Selland Arena - Auditorium  
 700 M Street, Fresno

Selland Arena (SA)

Seland Arena - Balcony Floor  
700 M Street, Fresno

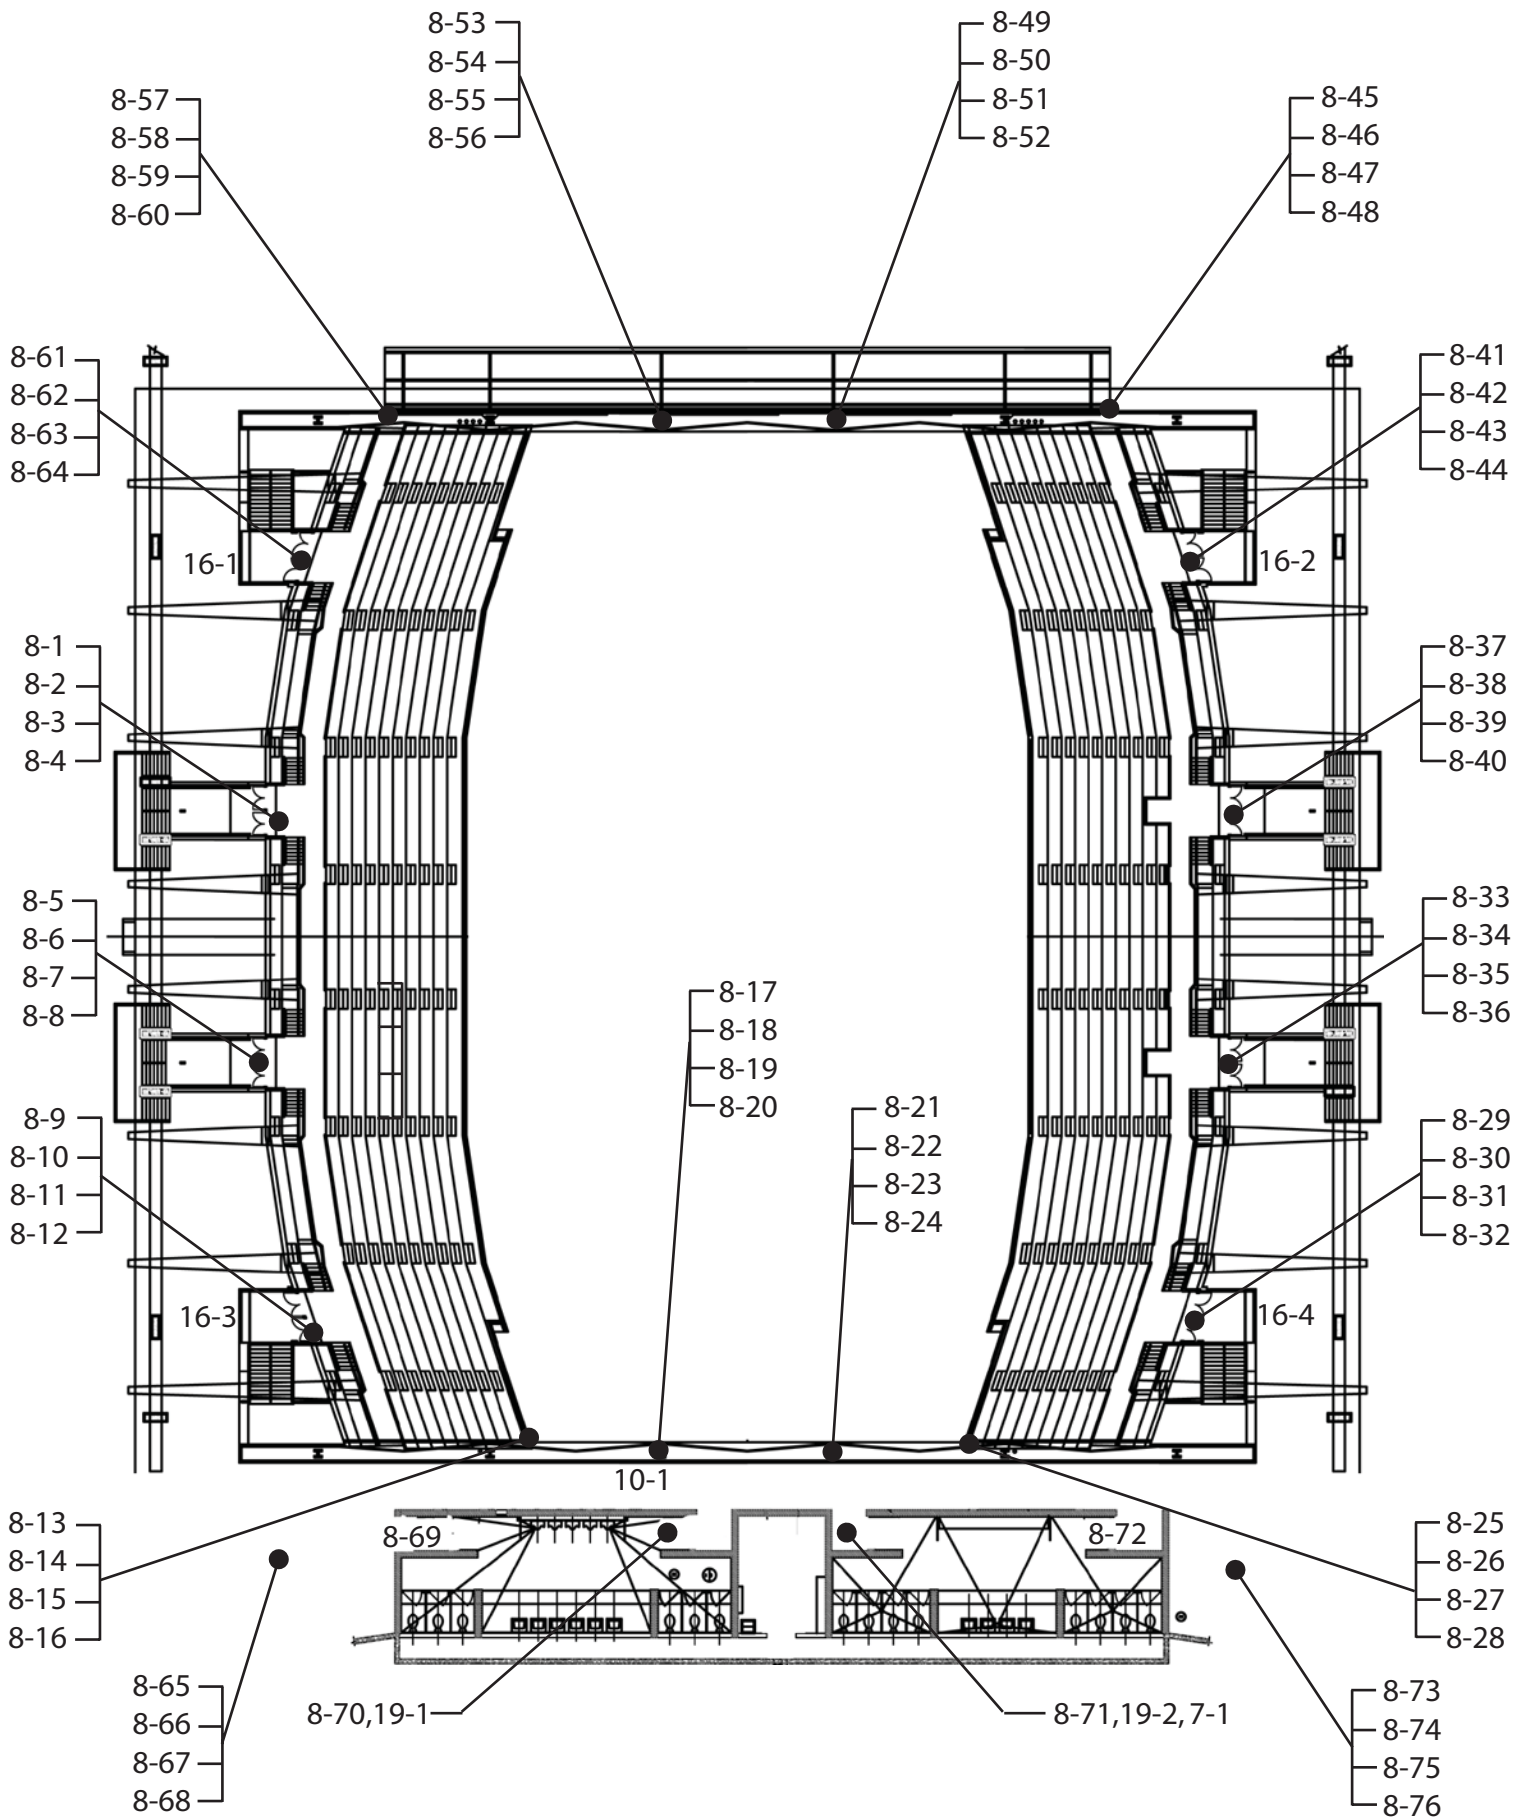
<b>Floor AUD</b>		
<b>6 - 3</b>	<b>Stairway</b>	Priority:2
<b>Install tread striping</b>		\$1,440
Notes: Indicator stripes are faded. There are 12 risers per set. There are 8 sets with the same issue.		
State: 1133B.4.4		
Federal: -		
<b>Replace stairs</b>		\$0
Notes: Width of stair is 35" (44" min). Tread width is 10-1/2" (11" min). There are 12 risers per set. There are 8 sets of the same staircase with the same issue.		
State: 1007.3, 1009.1, 1133B.4.5.3		
Federal: 4.9.2		
<b>Install or modify handrails</b>		\$48,000
Notes: Handrail with continuous gripping surface is only provided on one side. Top and bottom extensions are only provided on one side. Handrail diameter is 2" (1-1/4" to 1-1/2"). There is a total of 8 sets of handrails with the same issues.		
State: 1133B.4.1.1, 1133B.4.2.2, 1133B.4.2.5, 1133B.4.2.6		
Federal: 4.26.2, 4.9.4, 4.9.4 #2, 4.9.4 #3		
<b>6 - 4</b>	<b>Stairway</b>	Priority:2
<b>Install tread striping</b>		\$240

Notes: Indicator stripes are not contrasting. There are 16 risers.		
State: 1127B.4, 1133B.4.4		
Federal: -		
<b>Repair stair nosings</b>		\$6,000
Notes: Risers are open. There are 16 risers.		
State: 1133B.4.5.3		
Federal: 4.9.2		
<b>Install or modify handrails</b>		\$7,600
Notes: Extensions at the top and bottom are not provided. Handrail top surface is mounted 31" (34" to 38") AFF. Handrail diameter is 2" (1-1/4" to 1-1/2").		
State: 1133B.4.2.1, 1133B.4.2.2, 1133B.4.2.6		
Federal: 4.26.2, 4.9.4 #2, 4.9.4 #5

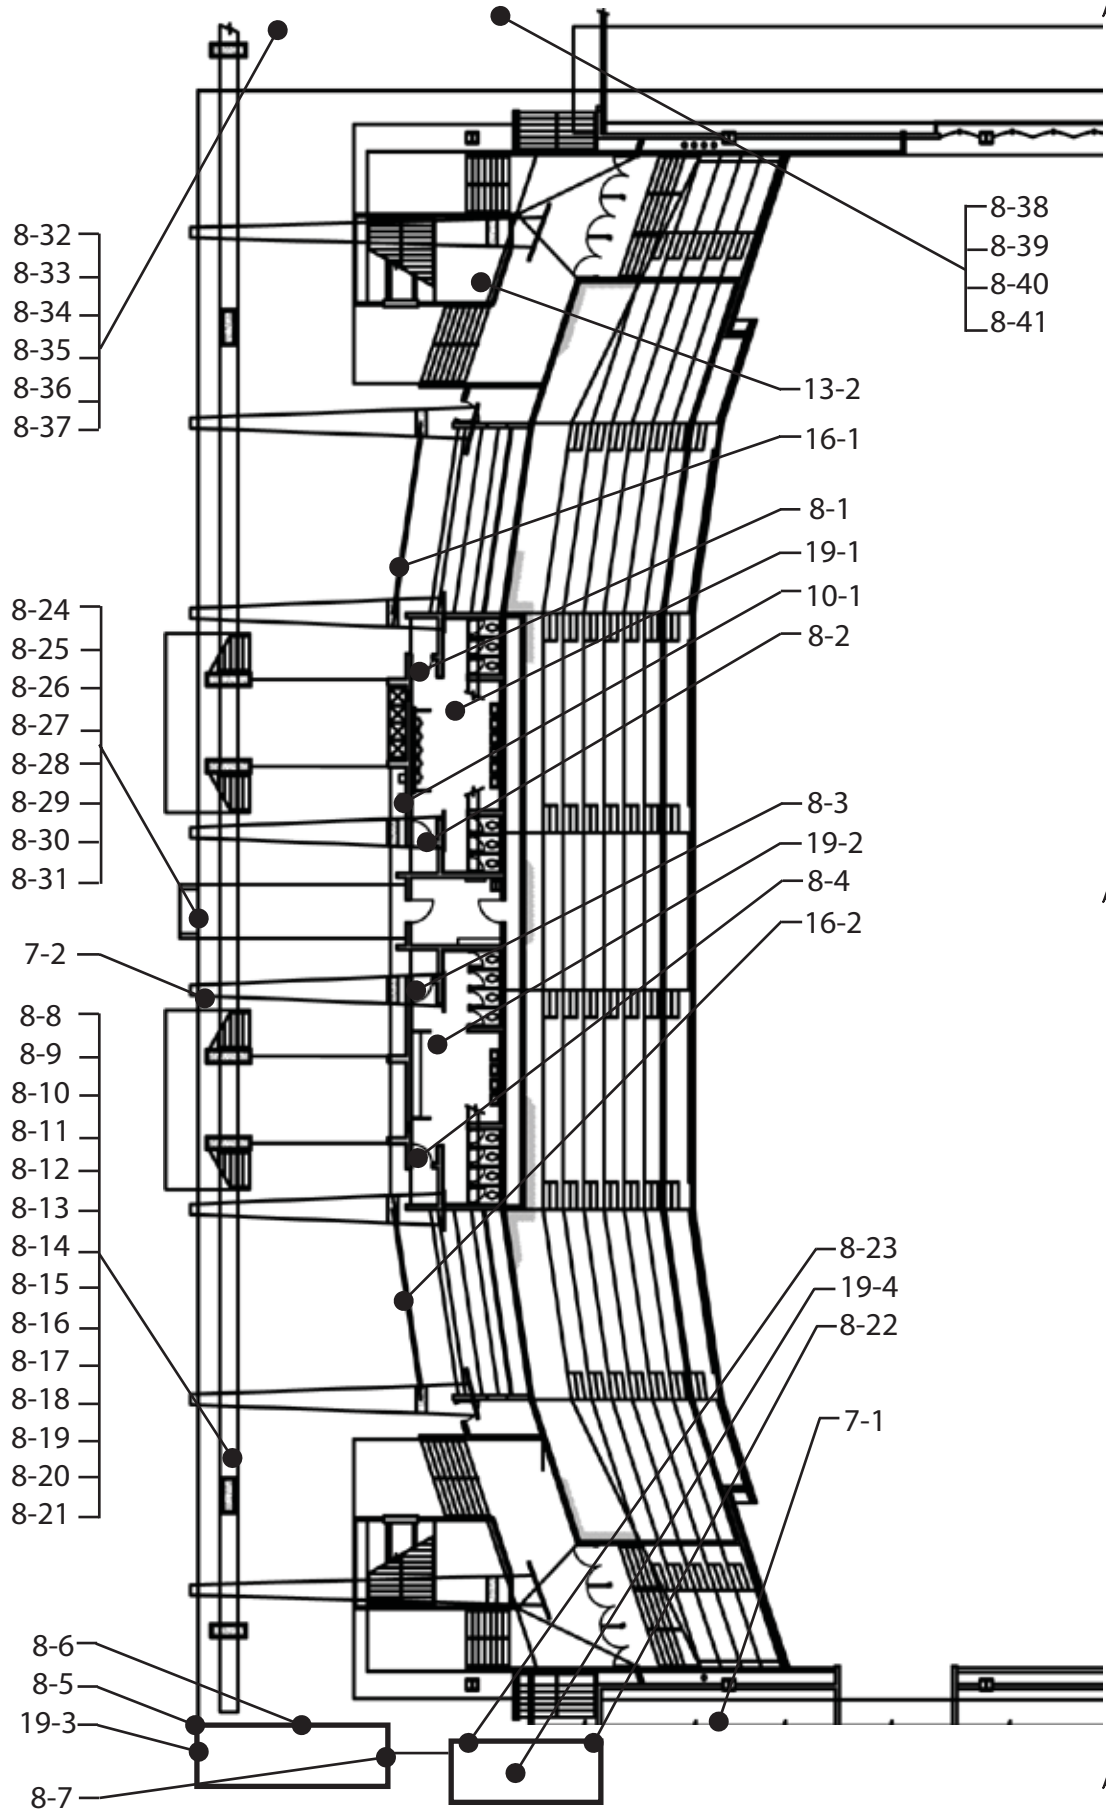
<b>Floor Balcony</b>	
<b>19 - 1 Multiple User Restroom</b>	<b>Priority:2</b>
<b>Replace toilet or adjust toilet seat height</b>	<b>\$200</b>
Notes: Toilet seat height is 16" (17" to 19" max) above the finished floor.	
State: 1115B.4.1 #4	
Federal: 4.16.3	
<b>Replace or reposition fixtures</b>	<b>\$1,000</b>
Notes: Space from the wall to the centerline of the toilet is 18-1/2" (18" req).	
State: 1115B.7.1.3	
Federal: 4.17.3	
<b>Replace or reposition dispensers or mirrors</b>	<b>\$100</b>
Notes: Seat cover dispenser is 41" (40" max) above the finished floor.	
State: 1115B.8.3	
Federal: 4.23.7	
<b>Provide an additional front transfer stall</b>	<b>\$2,500</b>
Notes: Front transfer stall is not provided.	
State: 1115B.3.1 #5, 1115B.4.1 #3, 1115B.5	
Federal: 4.17.3

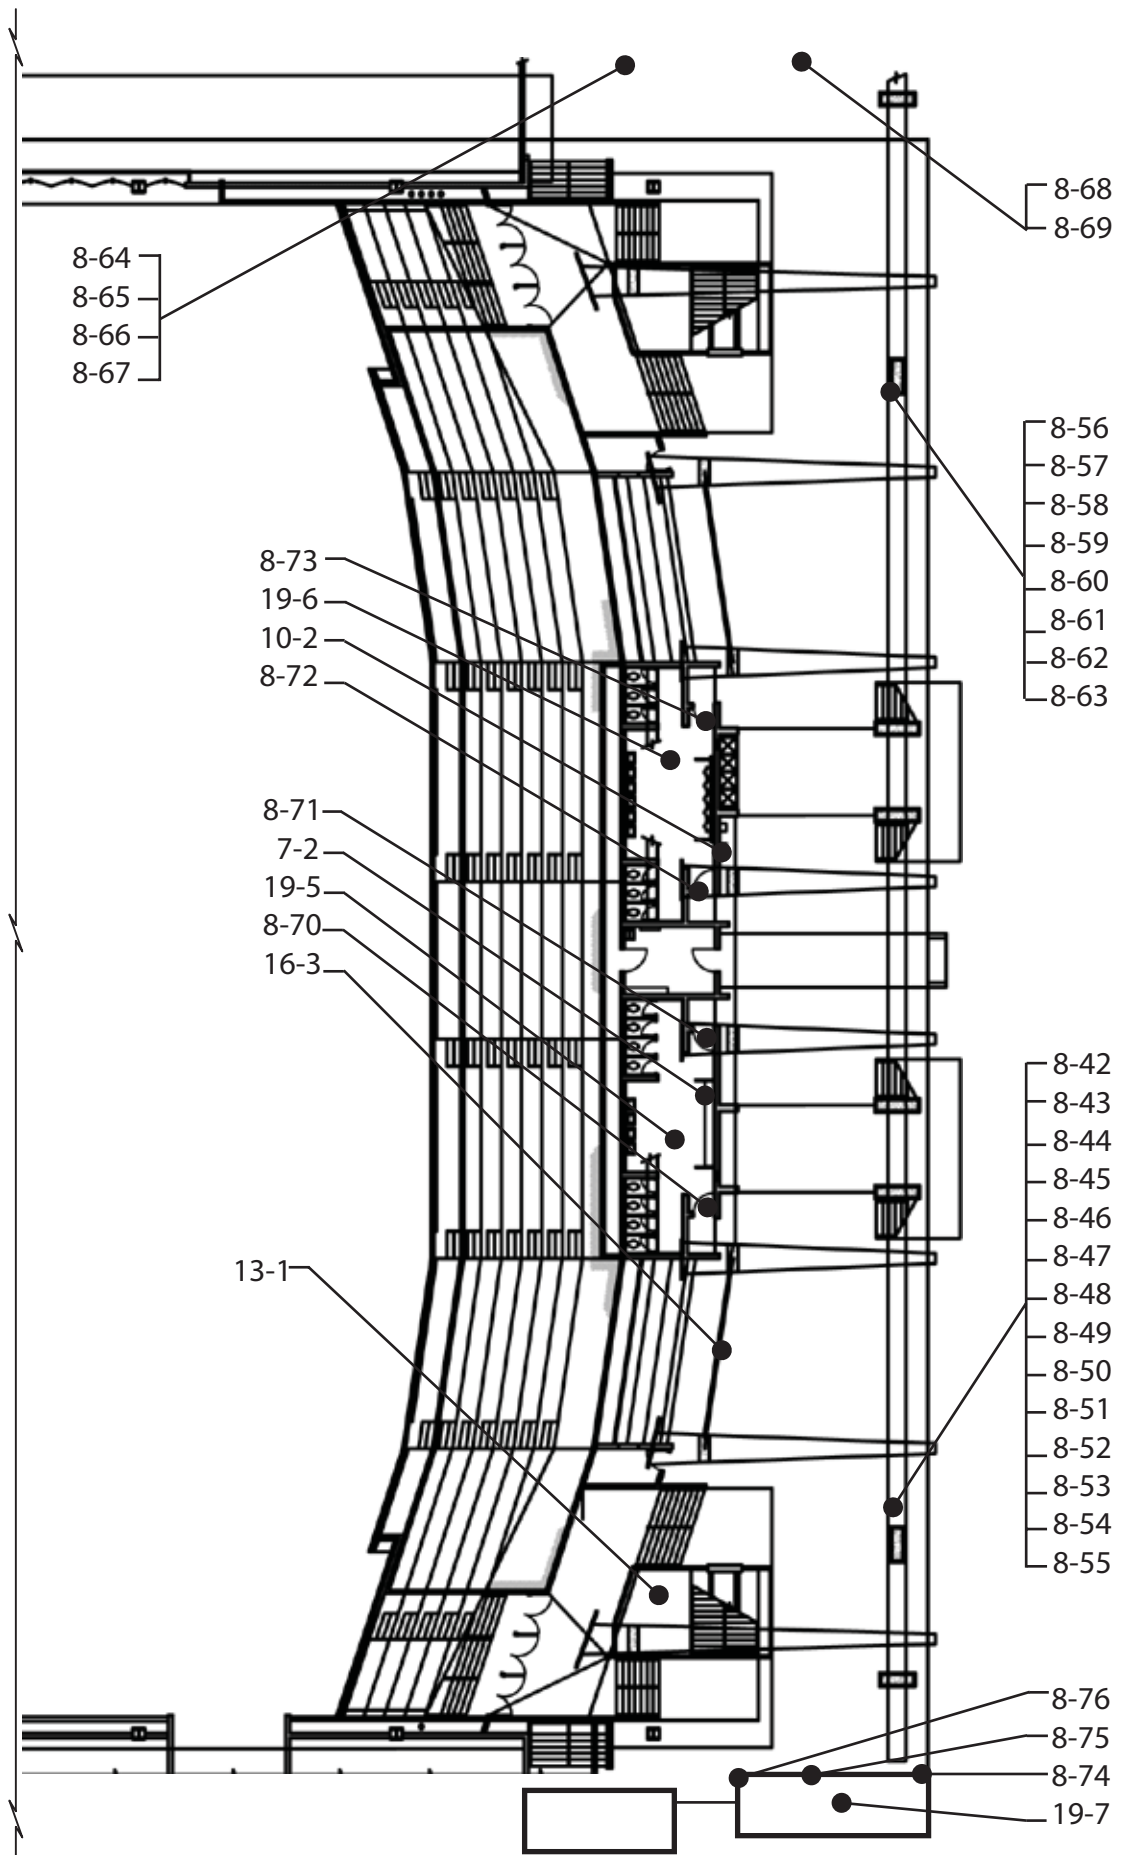
<b>Floor Balcony</b>	
<b>19 - 2 Multiple User Restroom</b>	Priority:2
<b>Modify stall partitions and doors</b>	\$500
Notes: Stall width is 59-1/2" (60" min).	
State: -	
Federal: 4.17.3	
<b>Provide or replace stall door hardware</b>	\$100
Notes: Stall door does not have U-shaped handle on the back. Stall door is not self-closing.	
State: 1115B.3.1 #4.5	
Federal: 4.13.9

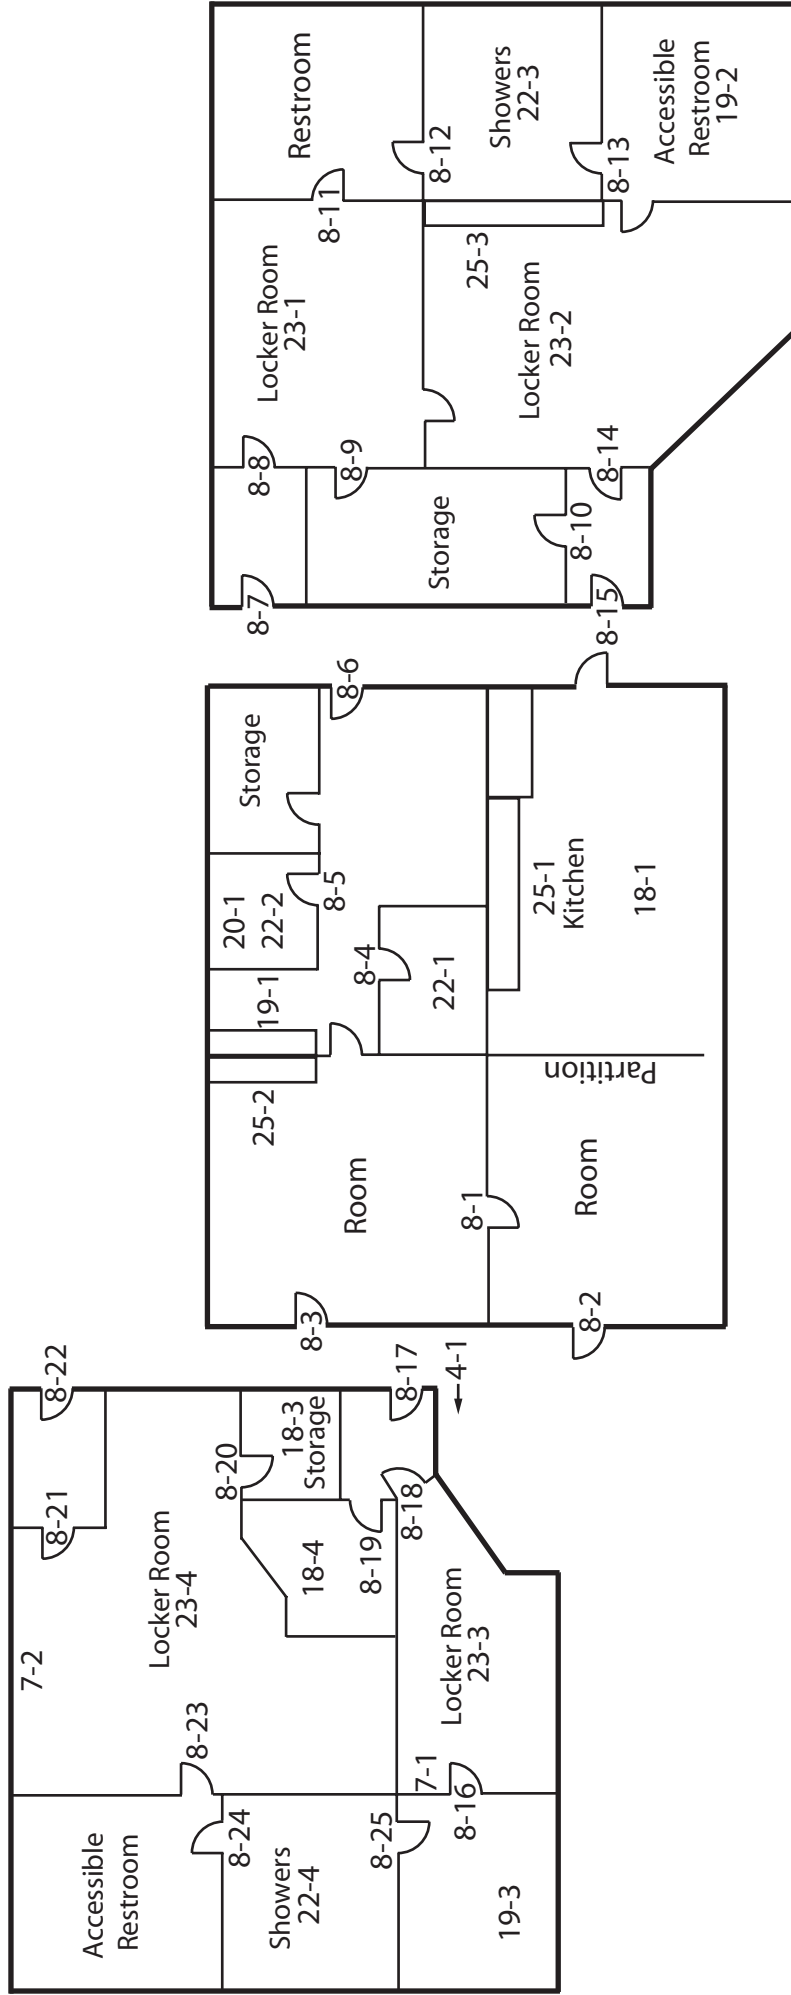
<b>Floor Loge</b>	
<b>19 - 6 Multiple User Restroom</b>	Priority:2
<b>Modify stall partitions and doors</b>	\$500
Notes: Space in front of the toilet is 30" (48" min).	
State: 1115B.3.1 #4.1	
Federal: 4.17.3	
<b>Provide an additional front transfer stall</b>	\$2,500
Notes: Front transfer stall is not provided.	
State: 1115B.3.1 #5, 1115B.4.1 #3, 1115B.5	
Federal: 4.17.3
